**Final Drainage Report Addendum
Peaceful Ridge at Fountain Valley Subdivision
El Paso County, Colorado**

Kiowa Project No. 04092 & 21031

Please add "PCD File No. CDR-22-015".

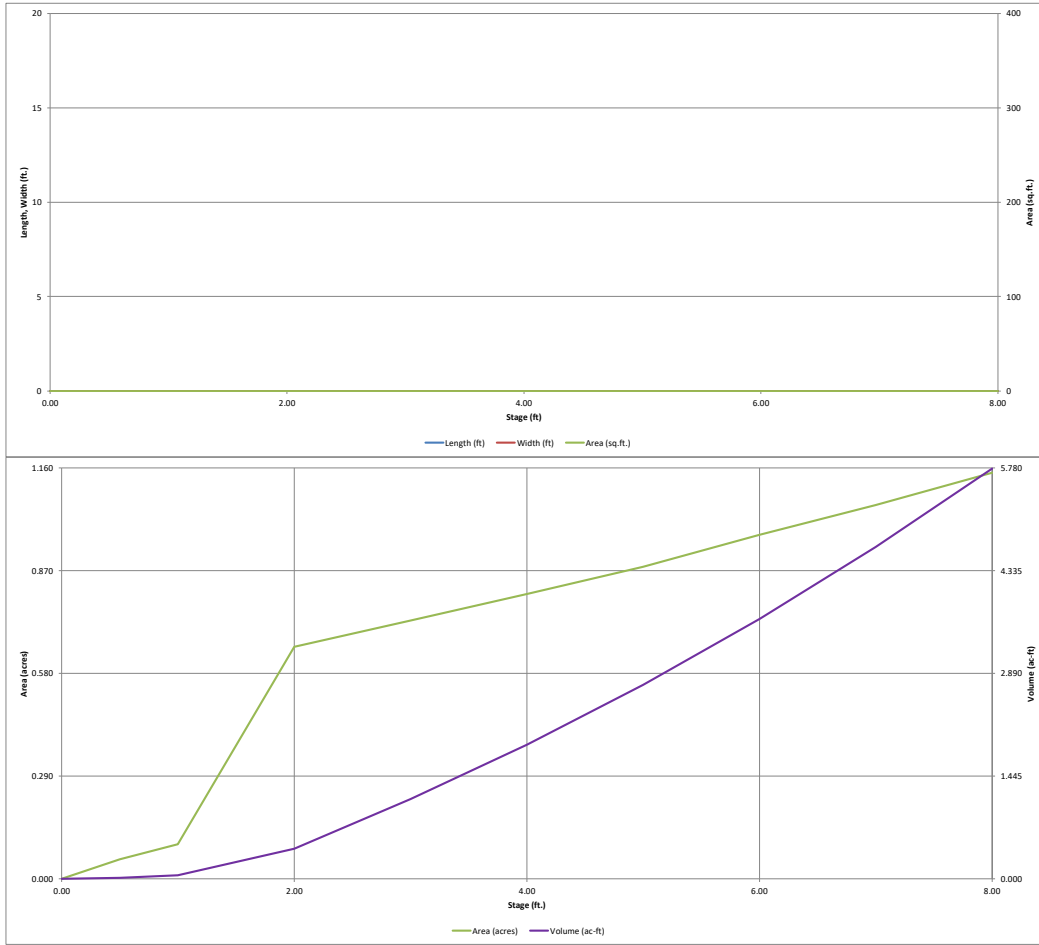
Revise inputs to match EGP inputs that have been approved previously. It does not appear that this sheet has been updated to match what was approved. Ensure that inputs match construction drawings as well.

Project: **04092 Peaceful Ridge at Fountain Valley Subdivision**
 Channel ID: **Existing swale along southern boundary line**

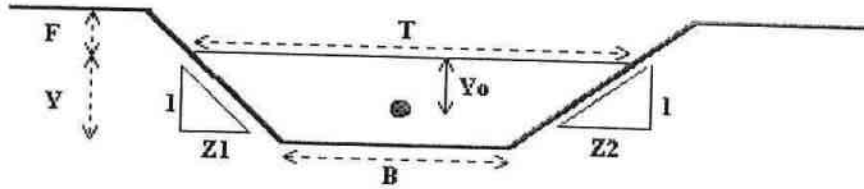
Provide updated analysis of the channel. Include recommendation for any necessary improvements.

Appendix D
Existing Conditions Map
Developed Conditions Map

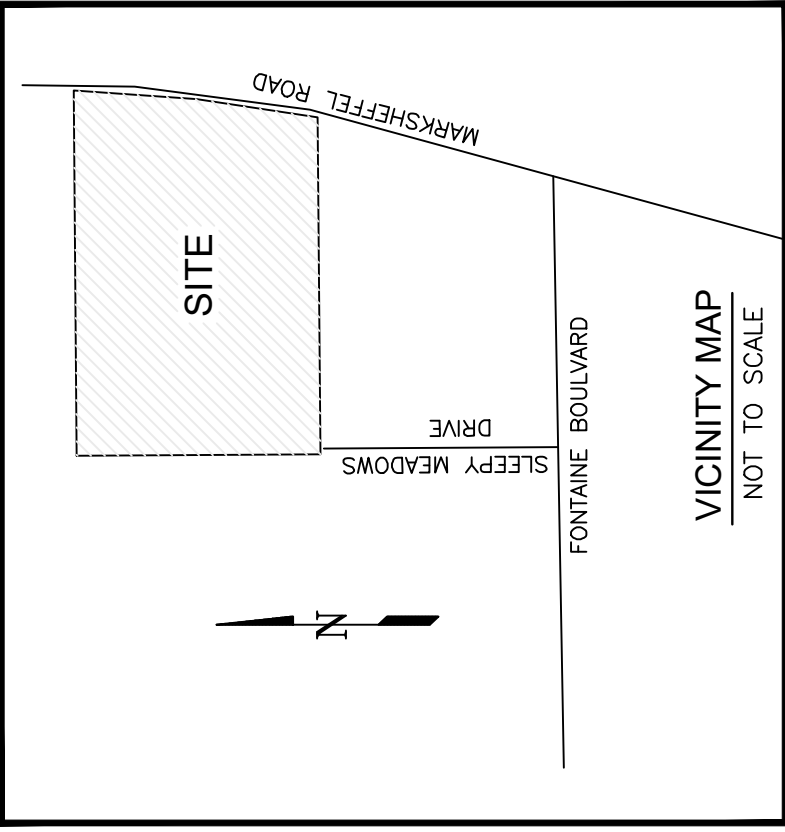
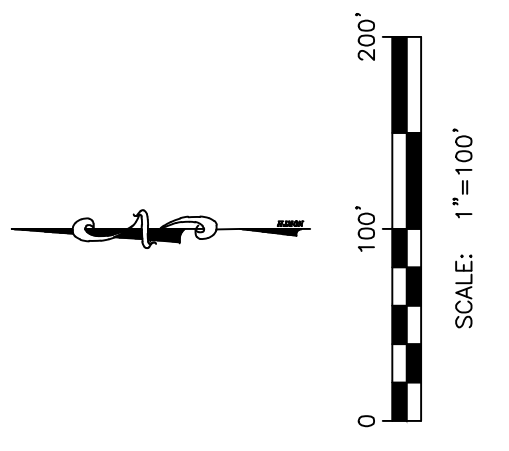
Move drainage maps to end of the report.

PEACEFUL RIDGE at FOUNTAIN VALLEY SUBDIVISION
FINAL DRAINAGE REPORT
DEVELOPED CONDITION
EL PASO COUNTY, COLORADO

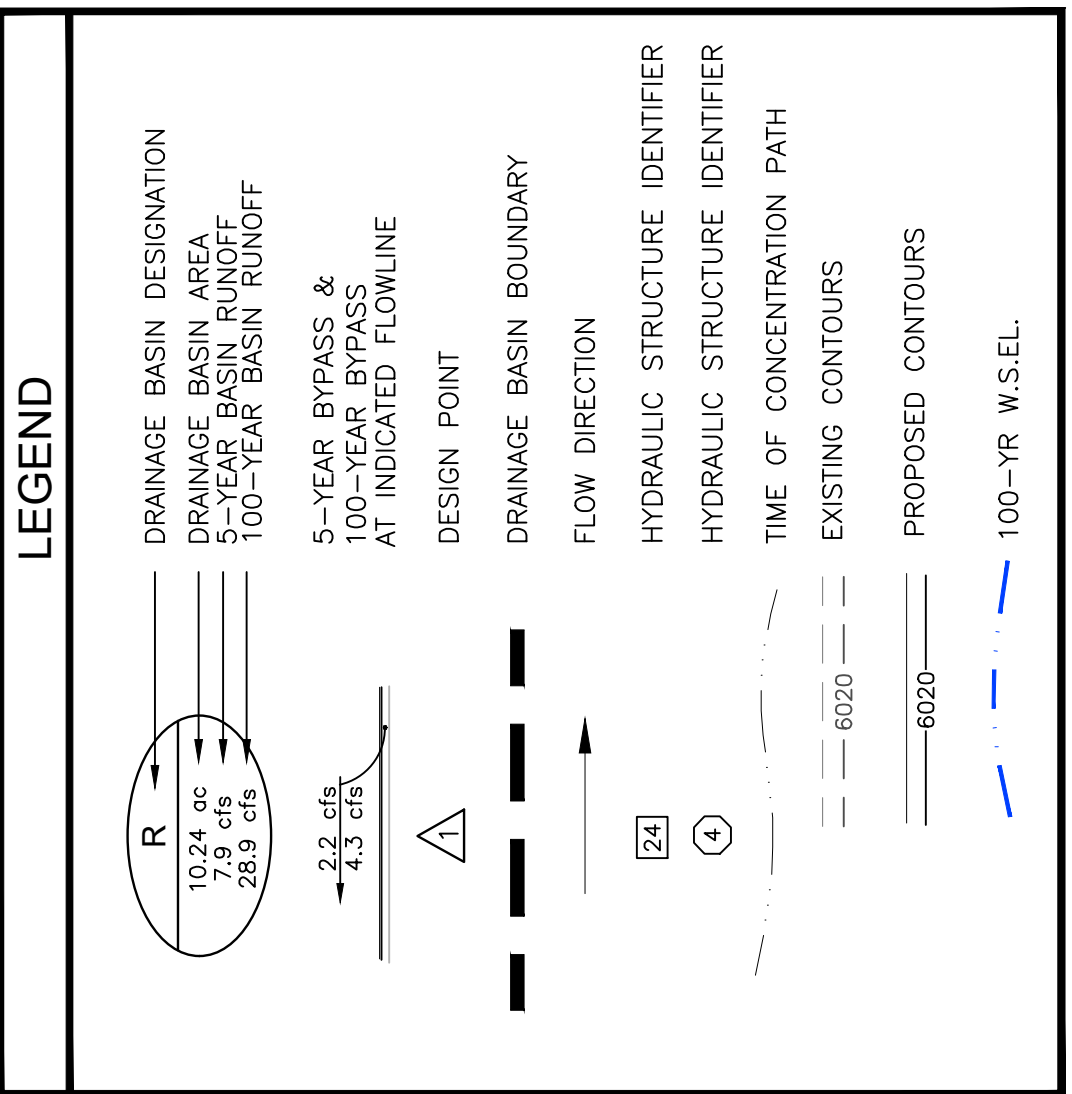
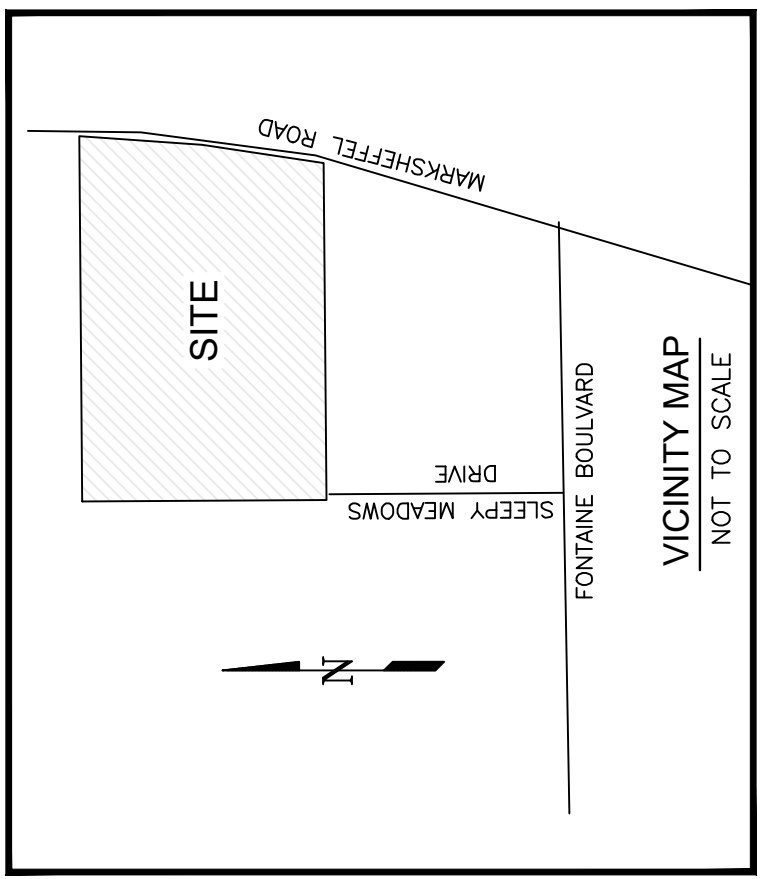
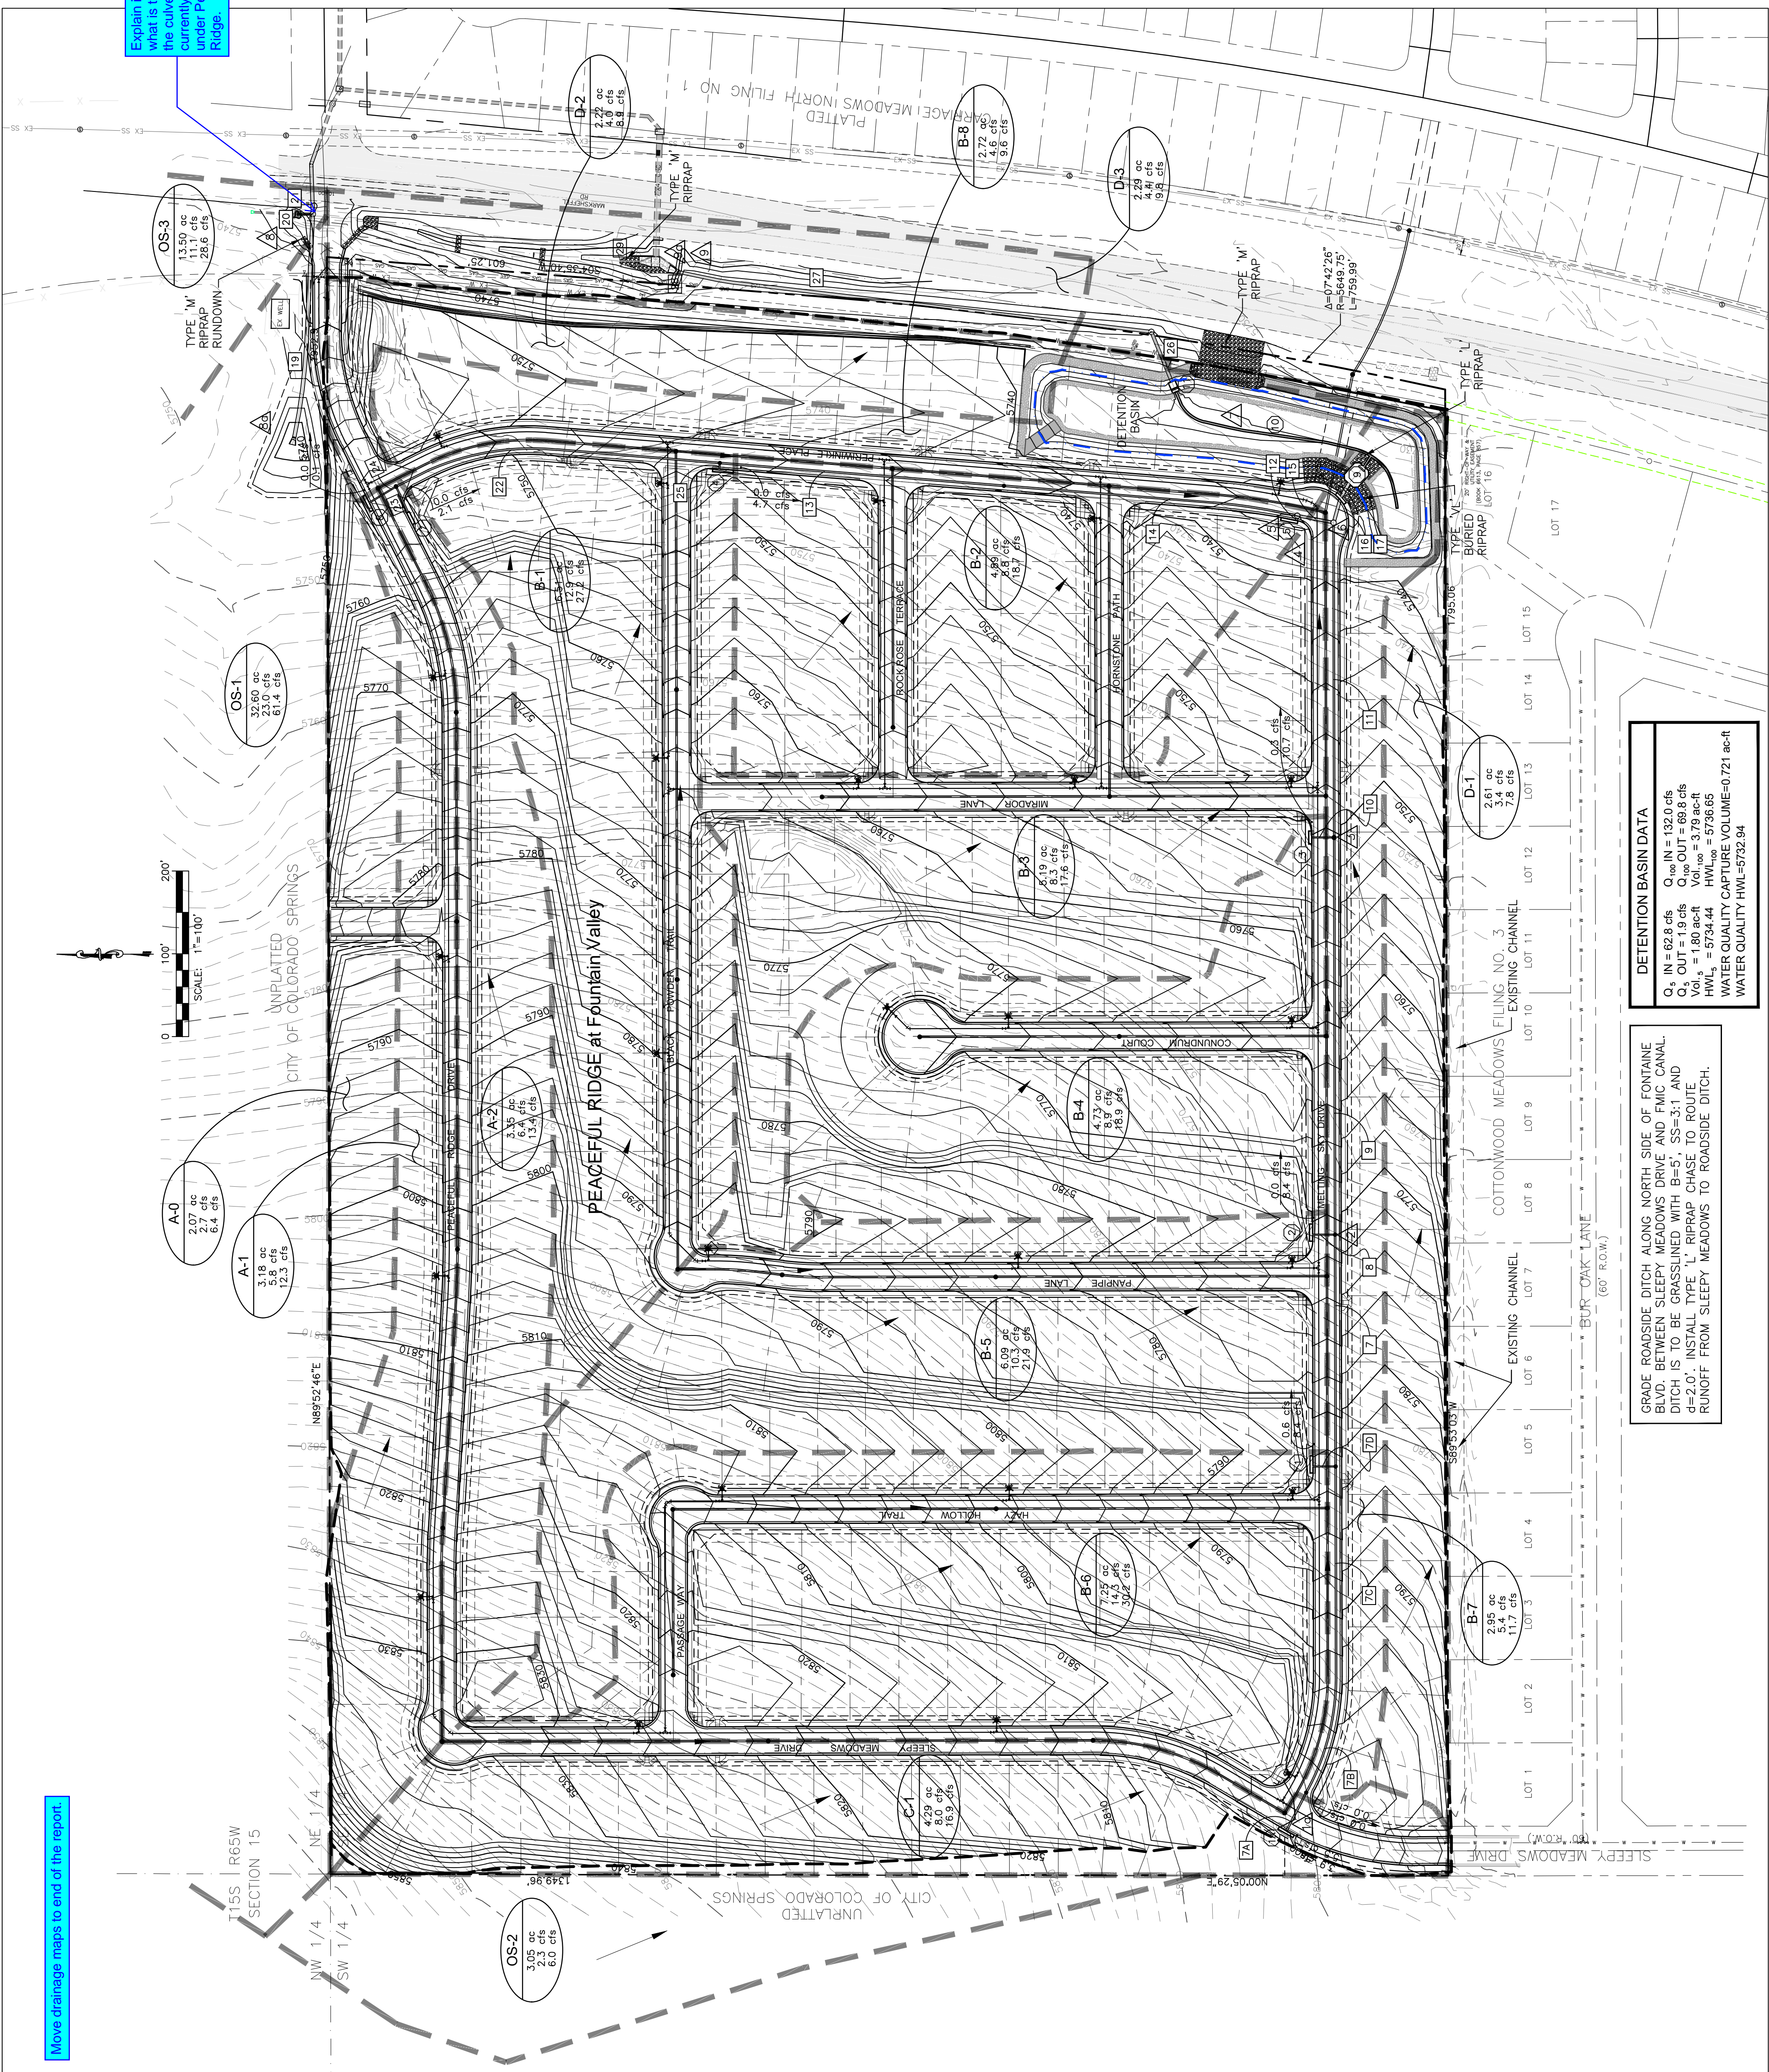
Explain in a narrative what is the plan for the current that is currently located under Peaceful Ridge.
